ADDENDUM

Project: PSC Fire Alarm Upgrade

Project No.: 23-131

Addendum No.: 1

ADMIN. BUILDING
FIRE ALARM - NEW

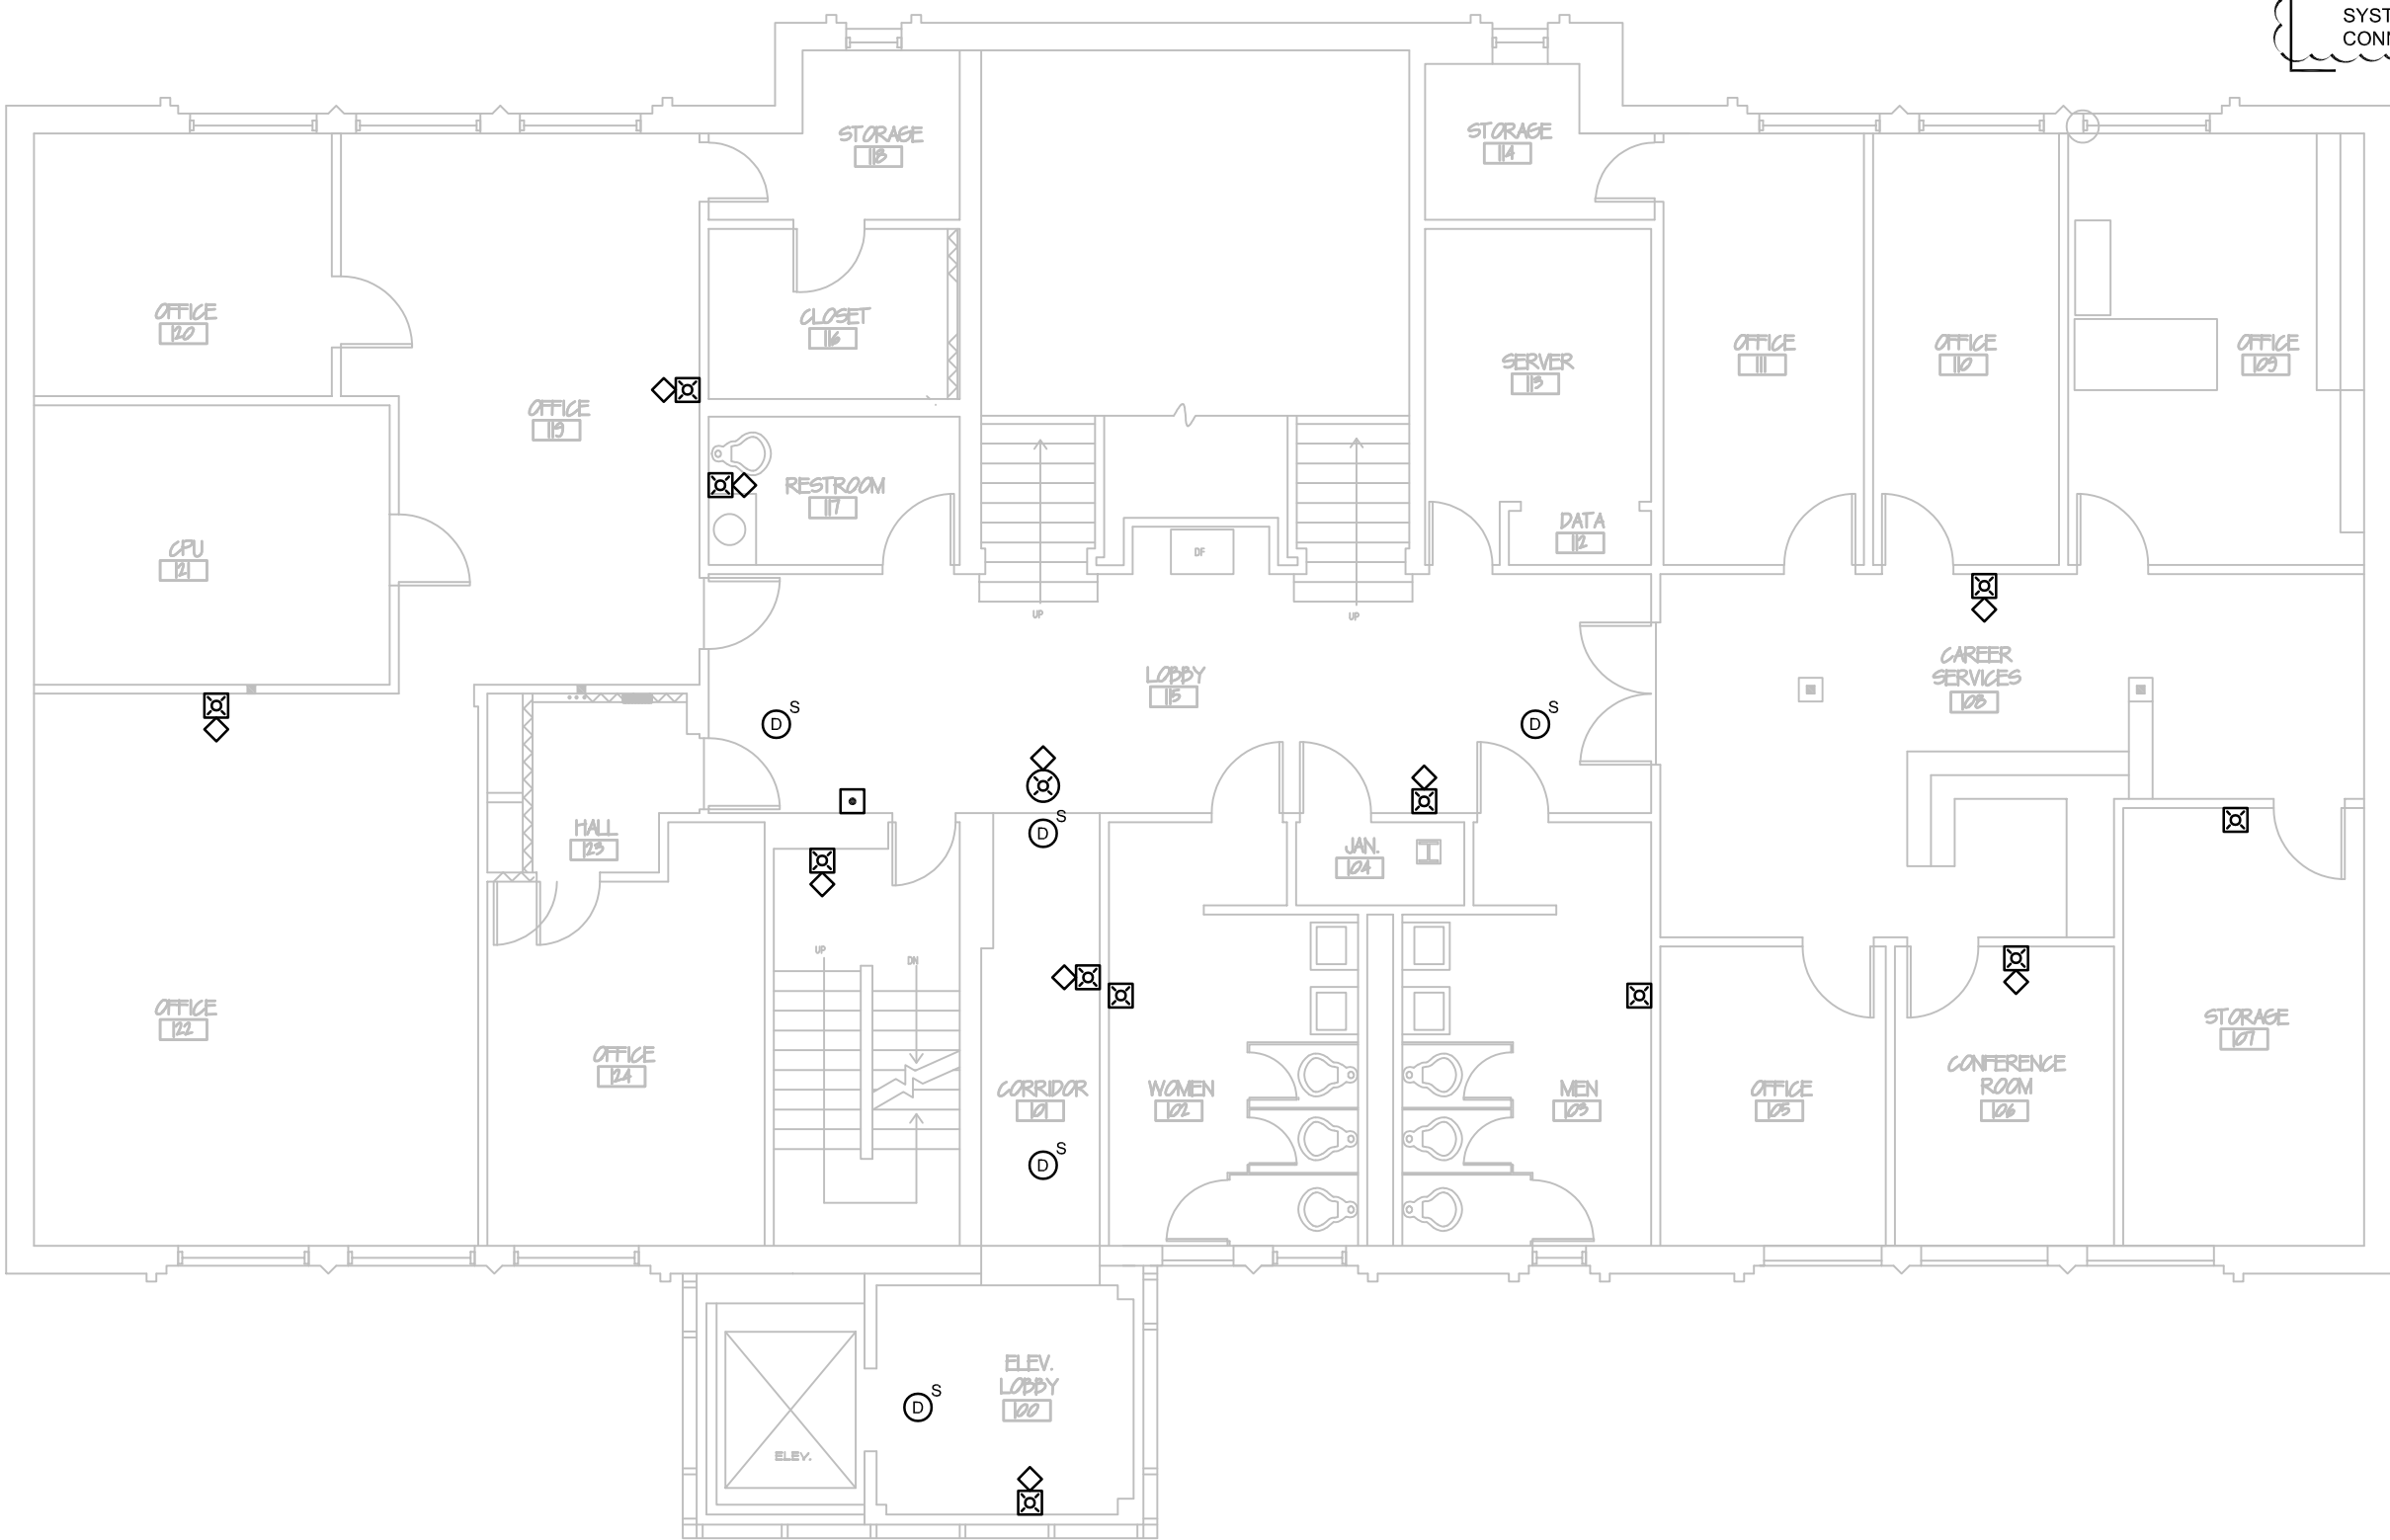
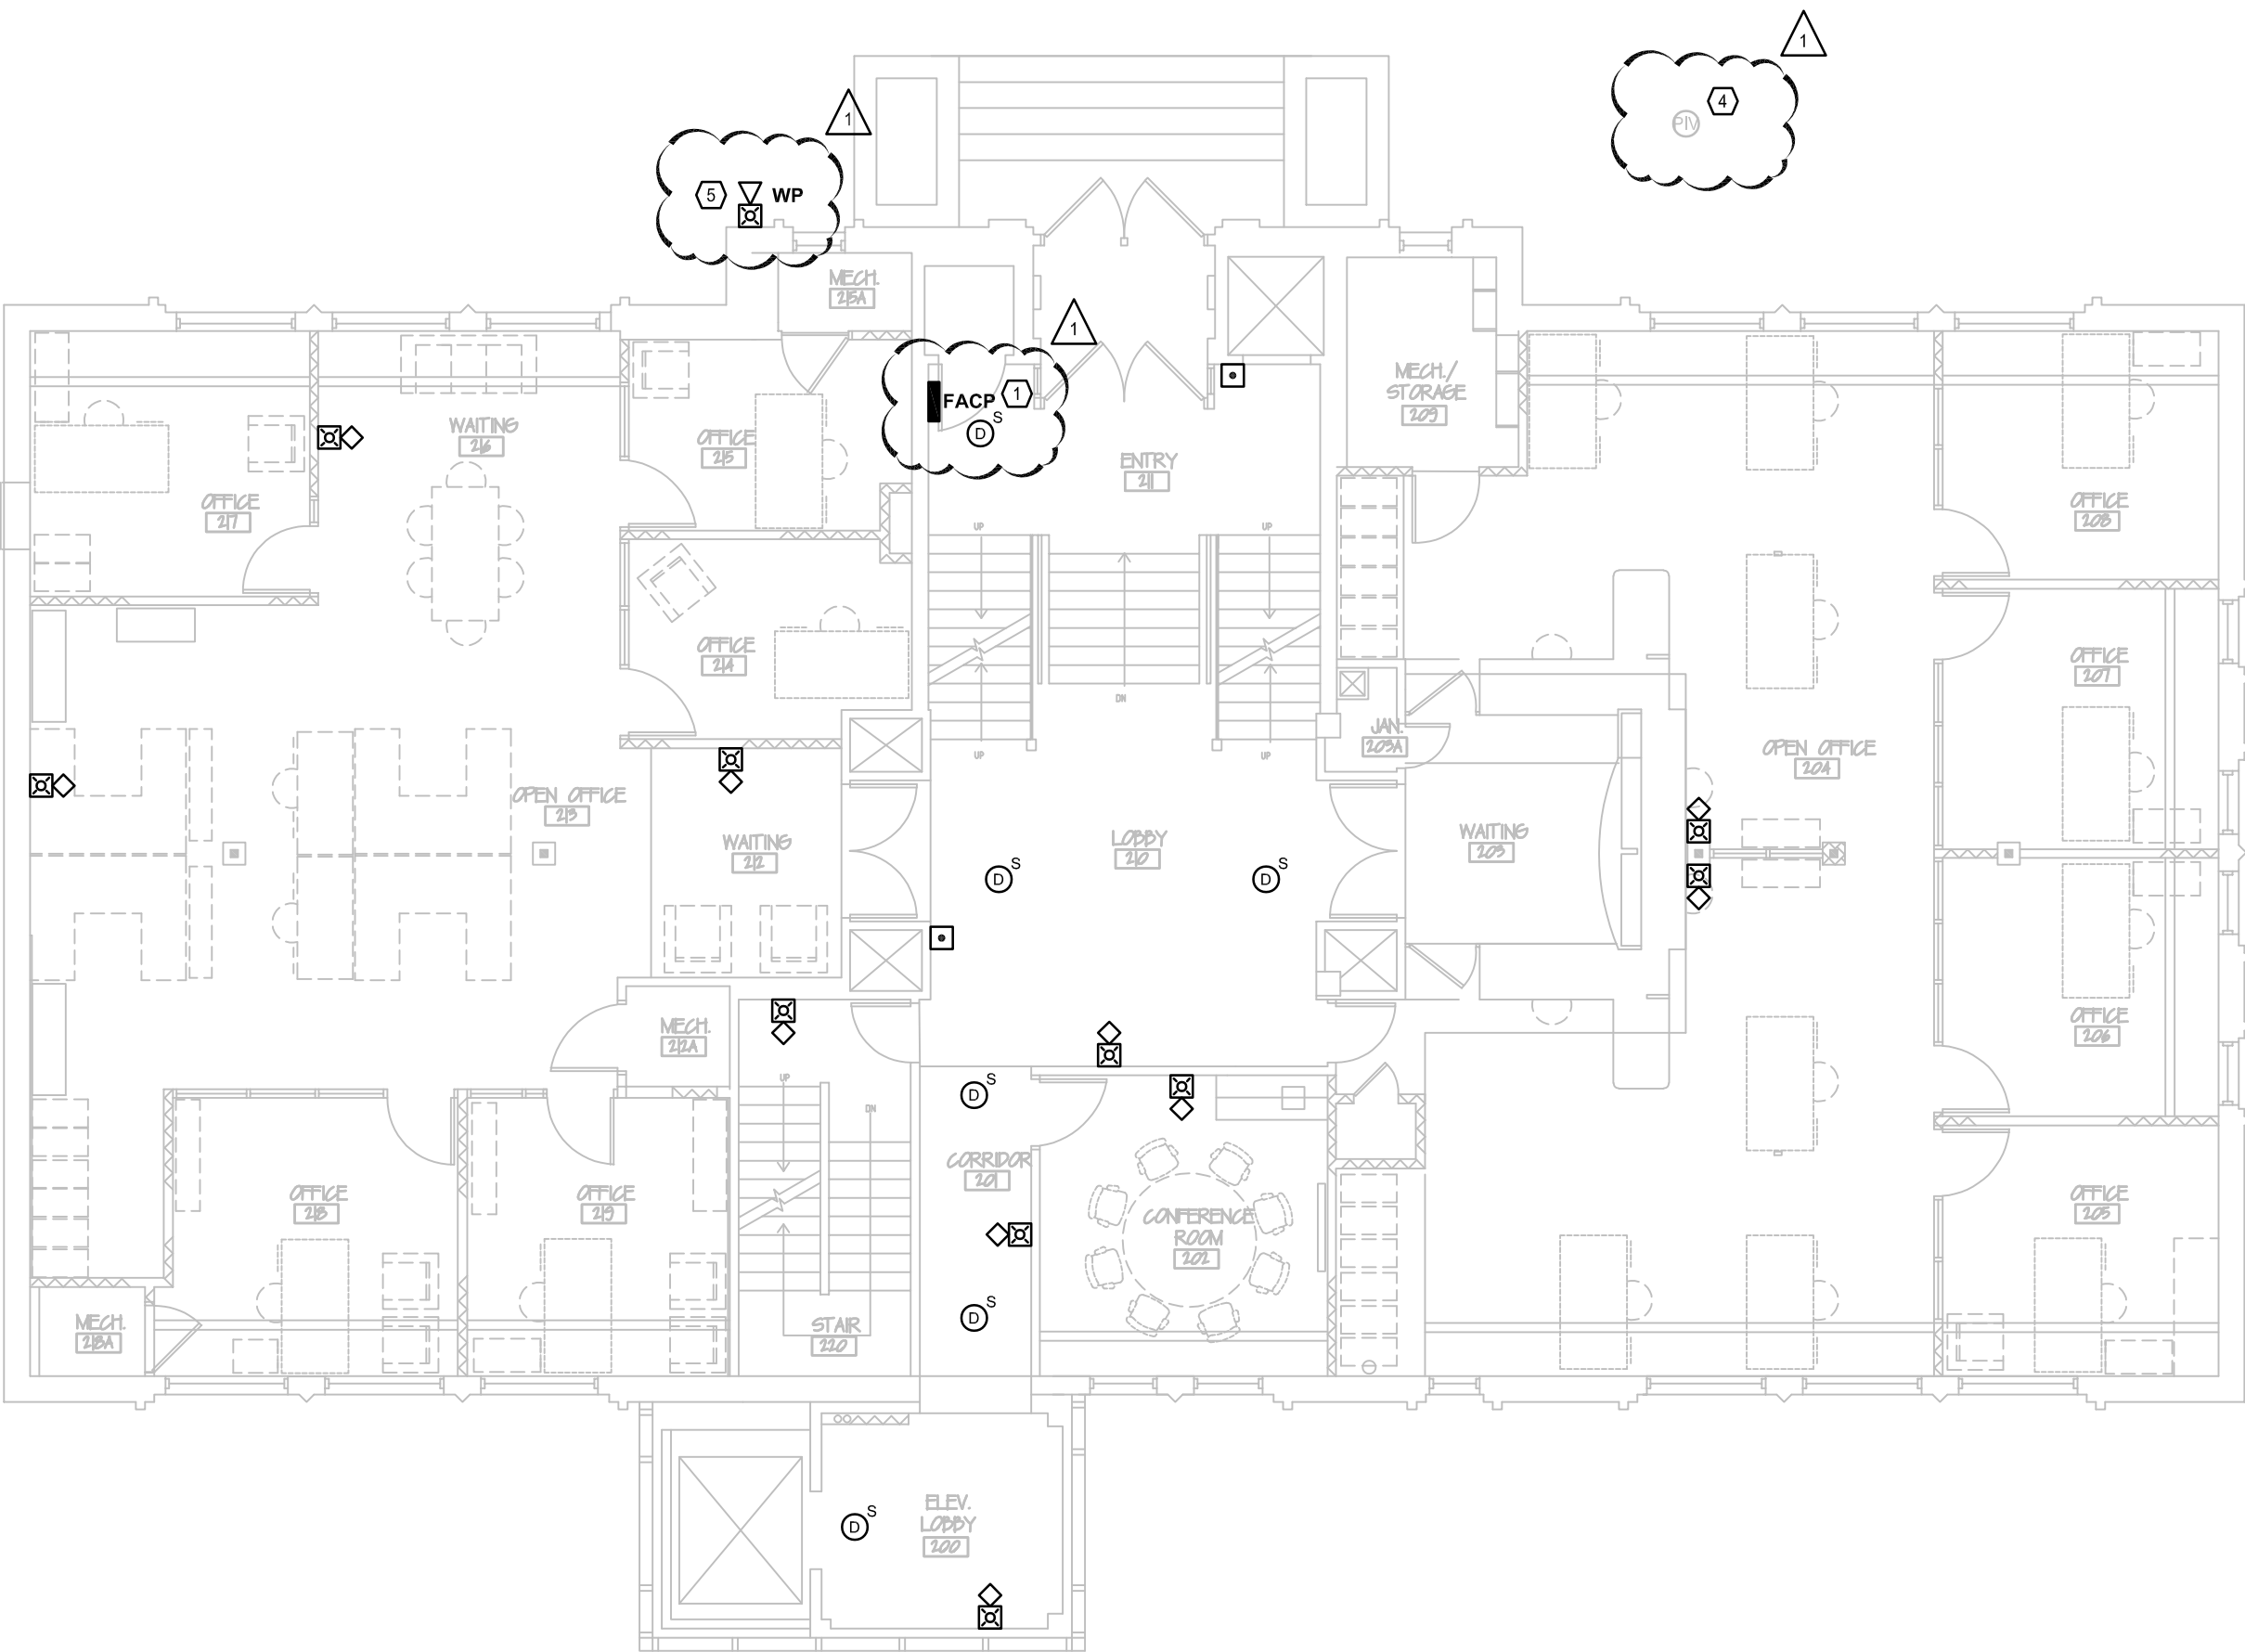
1. Added flow and tamper switch locations.
2. Added duct detectors.
3. Added PIV location.
4. Added WP horn/strobe.
